HOMESTEAD NORTH AT STERLING RANCH

EARLY GRADING AND EROSION CONTROL PLANS

PCD-ENGINEERING REVIEW COMMENTS
IN BLUE BOXES WITH BLUE TEXT

PCD FILING NO.: SP-20-008

TYPICAL WALKOUT LOT (W/O) OR GARDEN (G) NOT TO SCALE

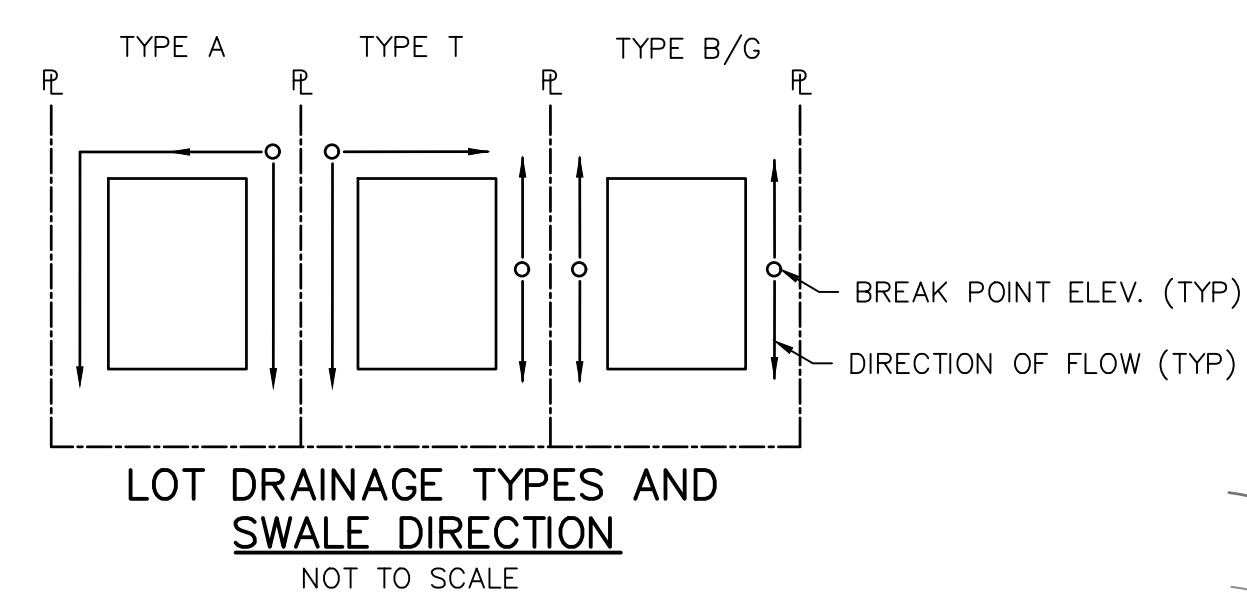
Provide cross-sections for all swales and spillways.

LOT DRAINAGE TYPES AND SWALE DIRECTION
NOT TO SCALE

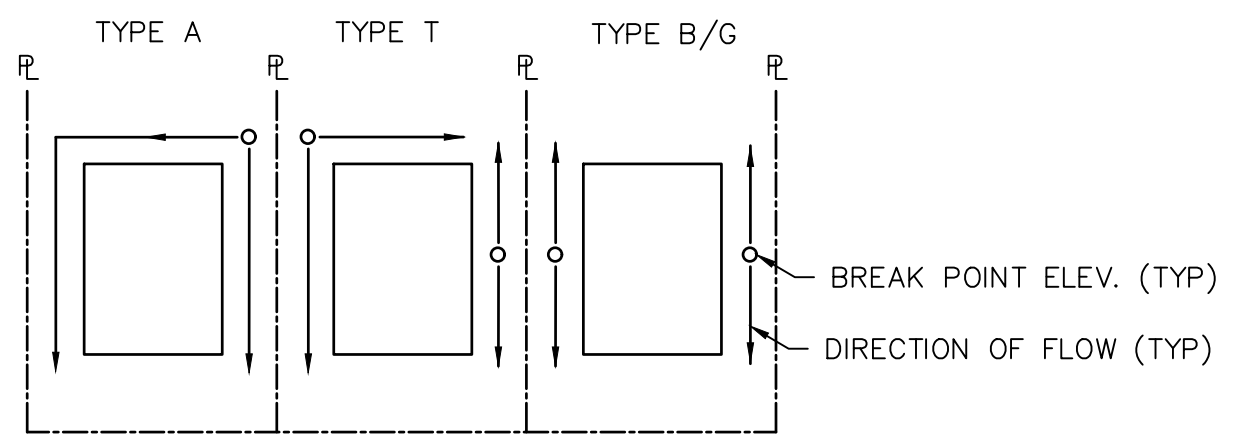
Provide erosion protection to bottom of channel

SHEET 3 OF 10
JOB NO. 25188.00

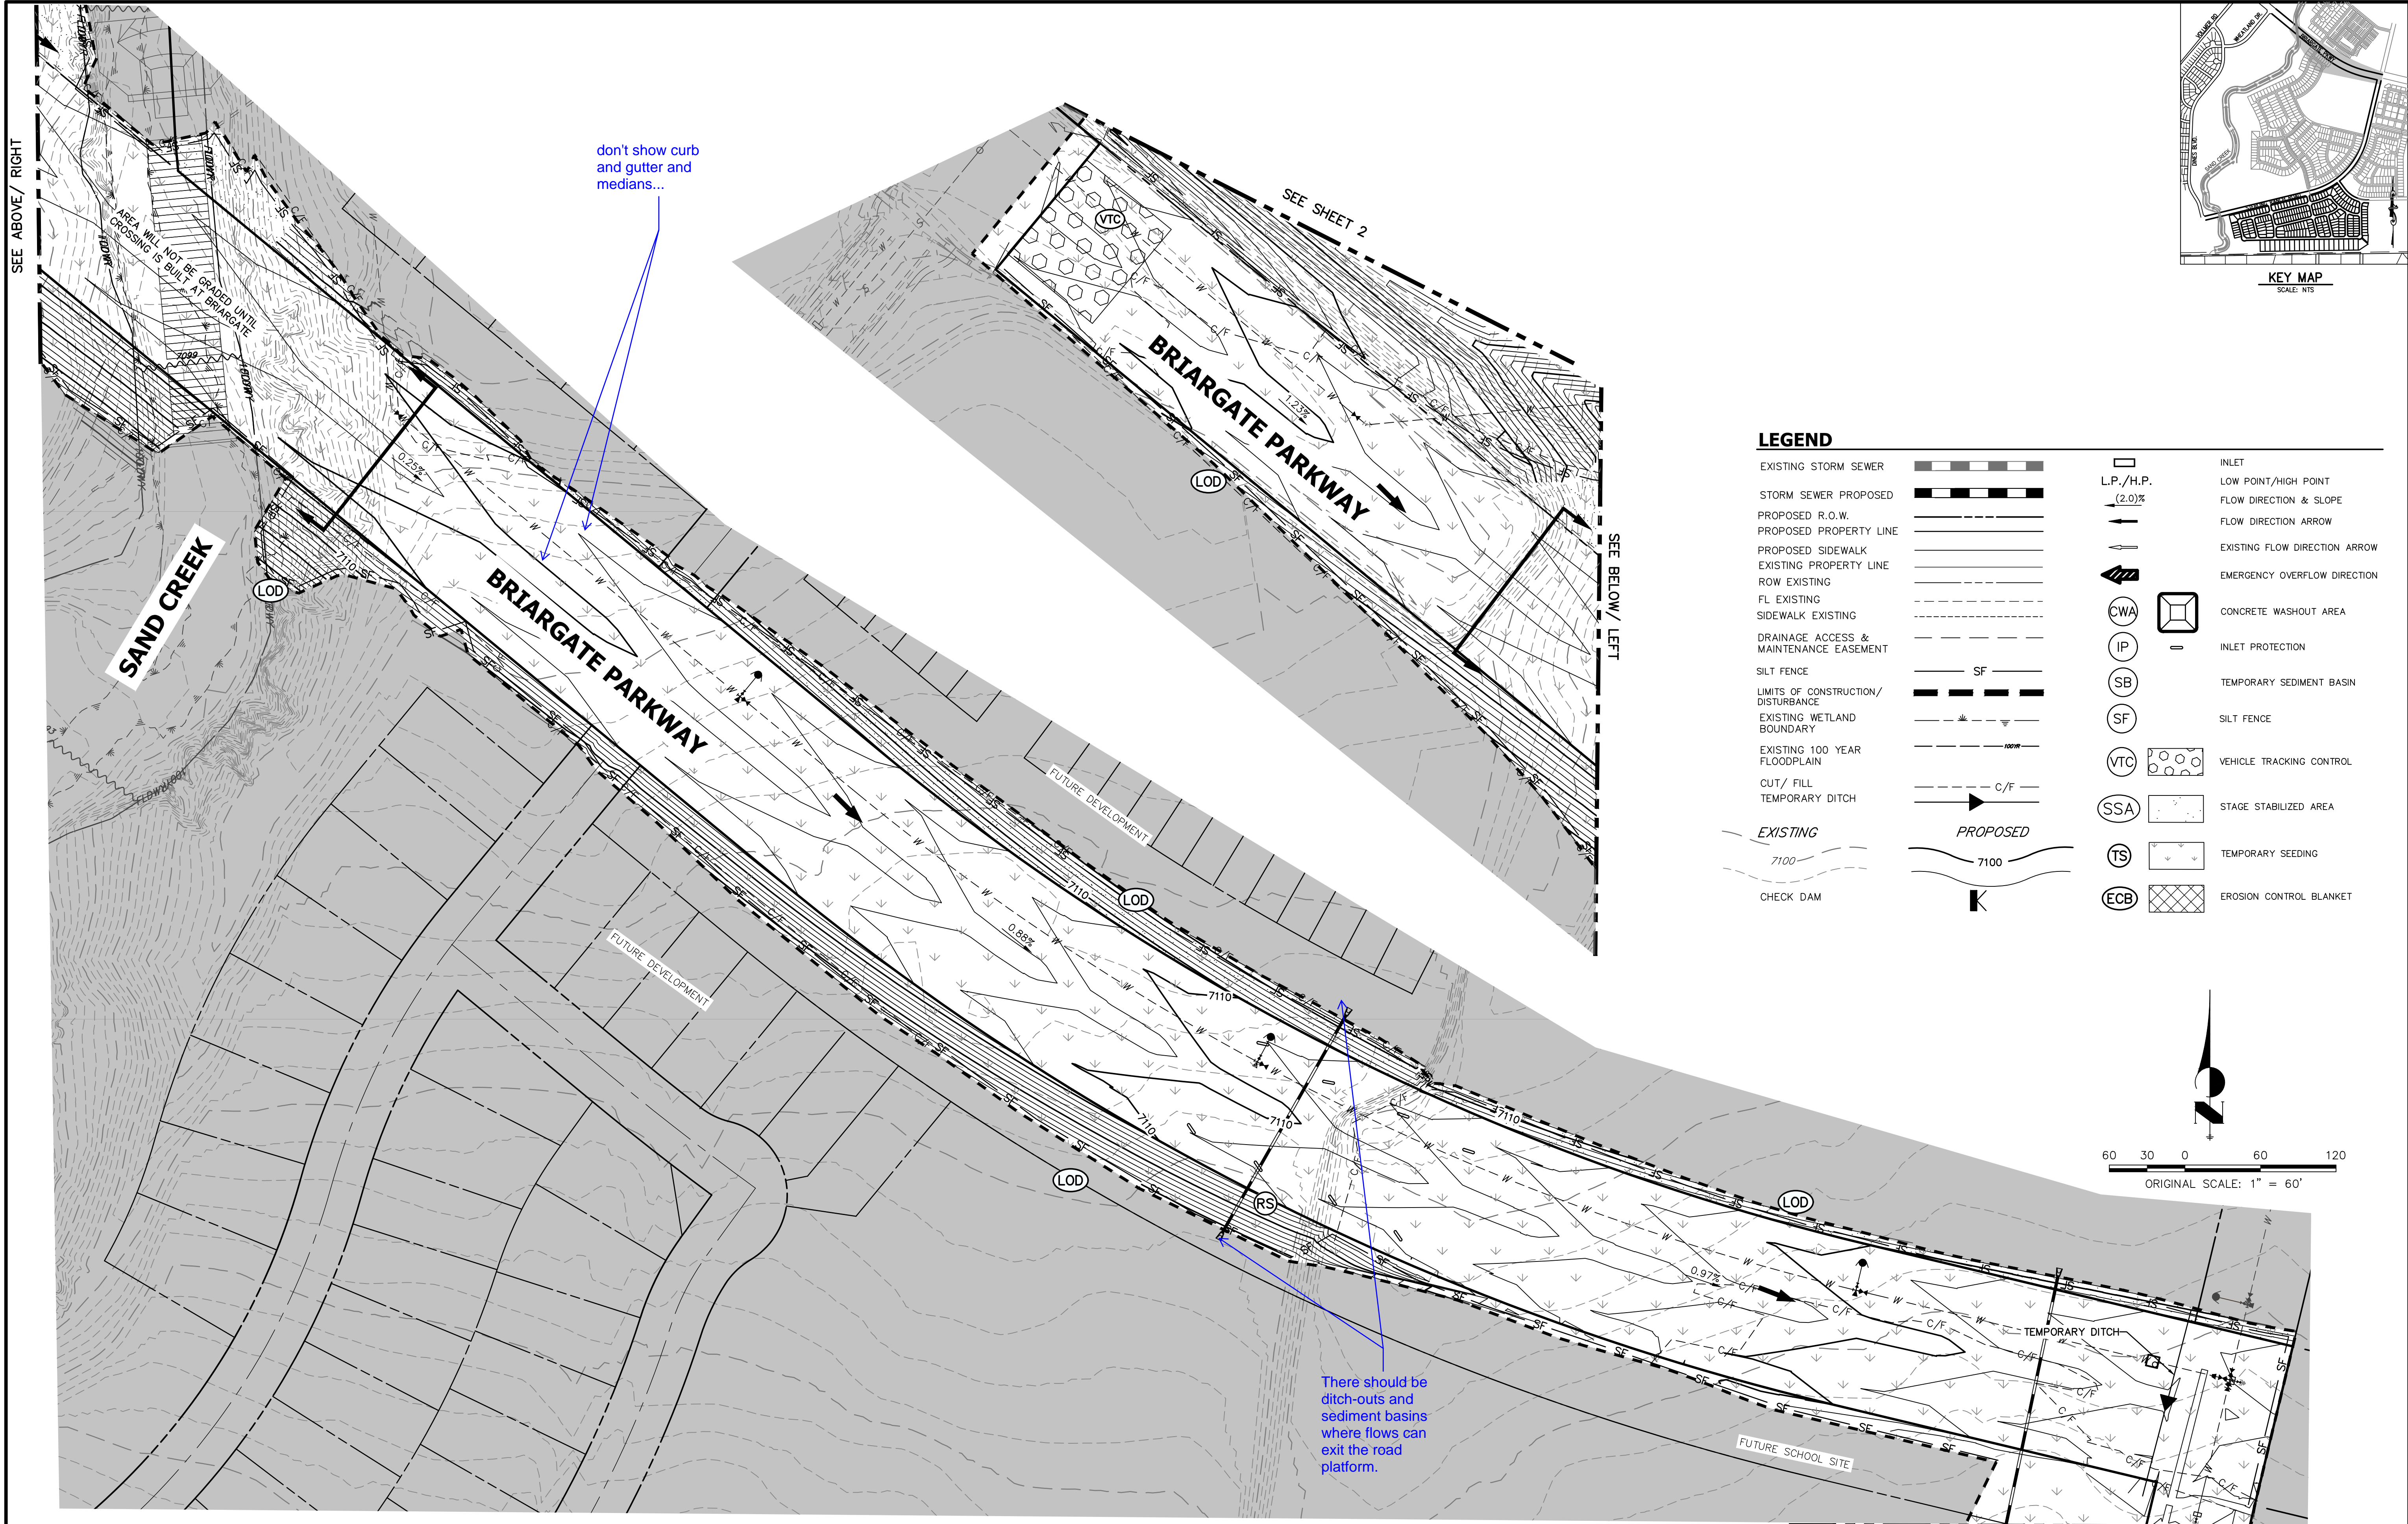
don't show curb and gutter and medians...

There should be ditch-outs and sediment basins where flows can exit the road platform.

much lower than FAE value

HOMESTEAD NORTH AT
 STERLING RANCH
 EARLY GRADING & EROSION
 CONTROL PLAN
 SHEET 5 OF 10
 JOB NO. 25188.00

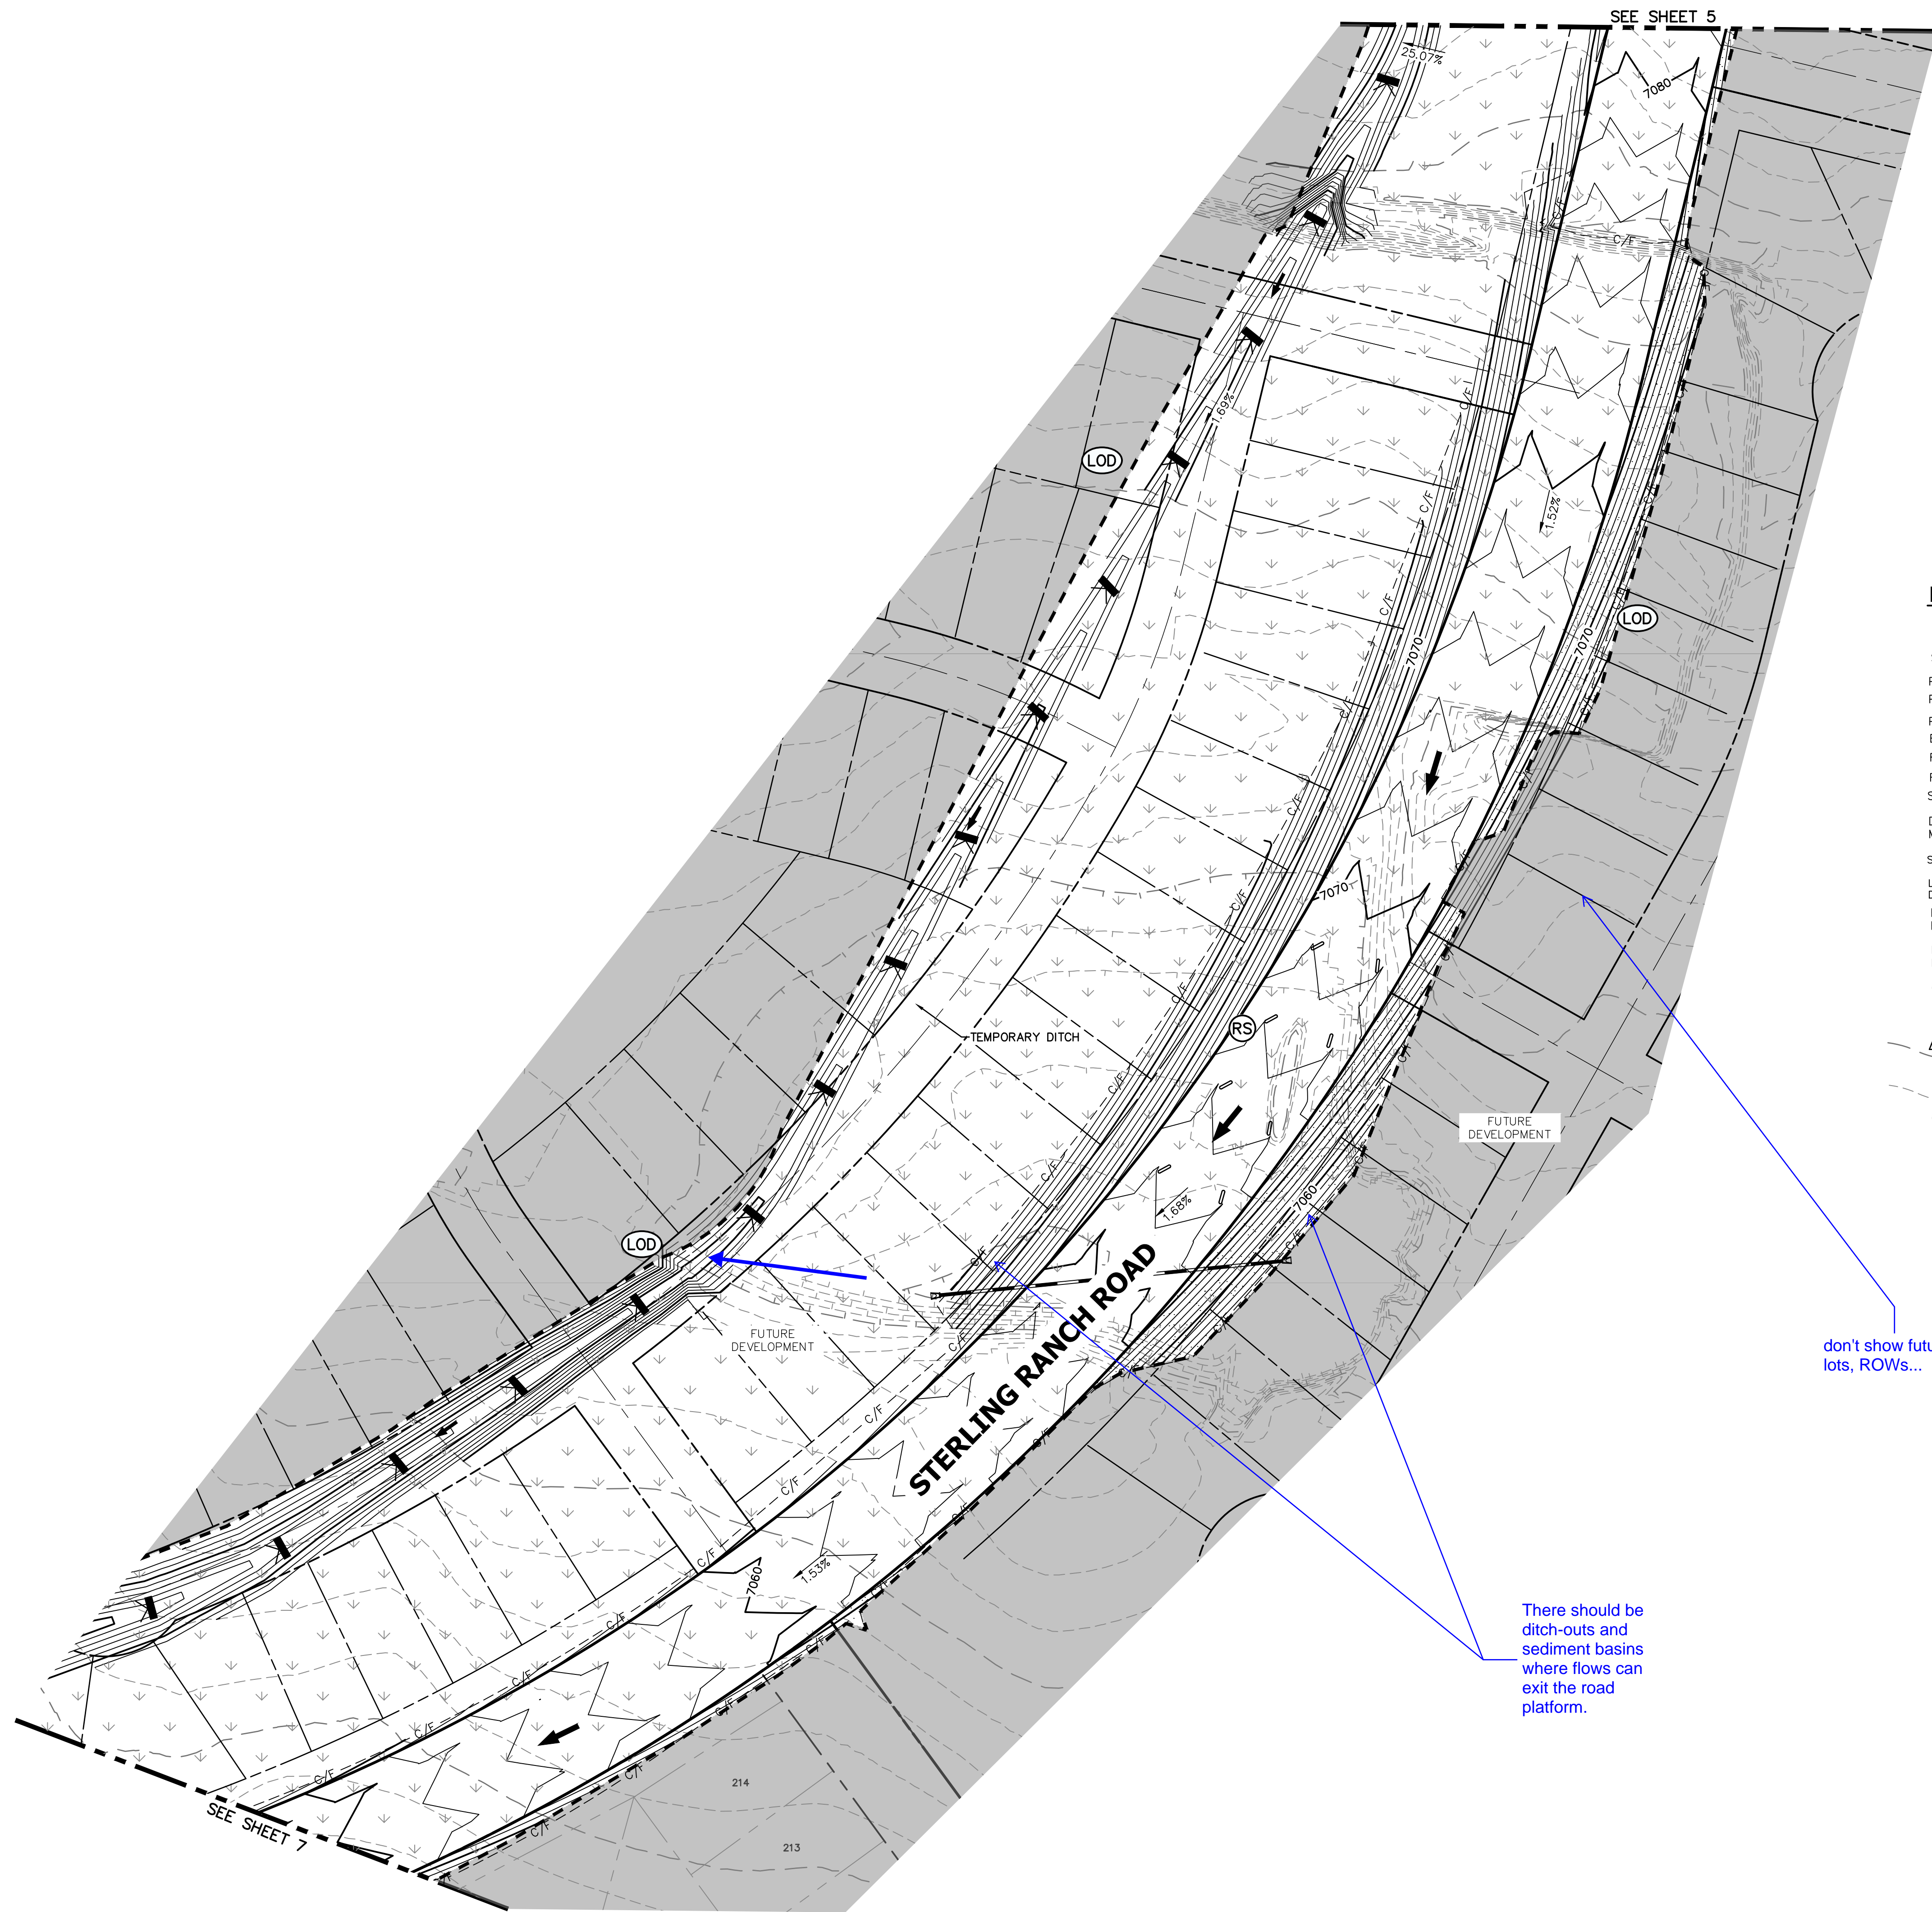
don't show future lots, ROWs...

There should be ditch-outs and sediment basins where flows can exit the road platform.
